**APPLICATION FOR PERMISSION
UNDER SECTION 16 OF
THE TOWN PLANNING ORDINANCE
(CAP. 131)**

For Official Use Only 請勿填寫此欄	Application No. 申請編號	A/YL-TYST/1264
	Date Received 收到日期	10 MAR 2024

**Proposed Temporary Warehouses for Storage of Electronic Goods and Construction Materials for a Period of 3 Years
at**

Government Departments' General Comments

Proposed Layout Plan

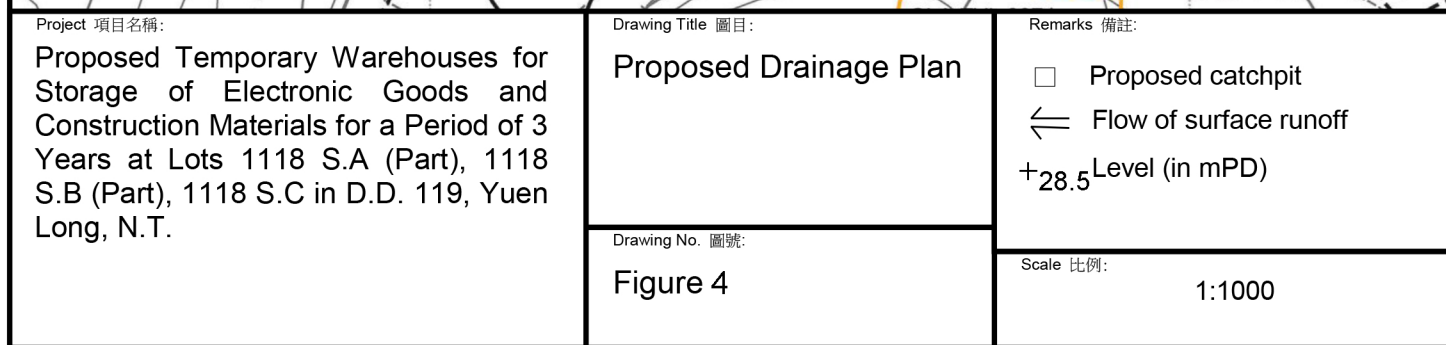
- (iv) considerations should be given to provide grating for the surface channels;
 - (v) the cover levels and invert levels of the proposed u-channels, catchpits/sand traps should be shown on the drainage plan;

- (i) to note the comments of the Director of Fire Services (D of FS) that:
 - (i) in consideration of the design/nature of the proposal, fire service installations (FSIs) are anticipated to be required. Relevant layout plans incorporated with the proposed FSIs should be submitted to his department for approval;

- (ii) the layout plans should be drawn to scale and depicted with dimensions and nature of occupancy, and the location of proposed FSIs to be installed should be clearly marked on the layout plans; and
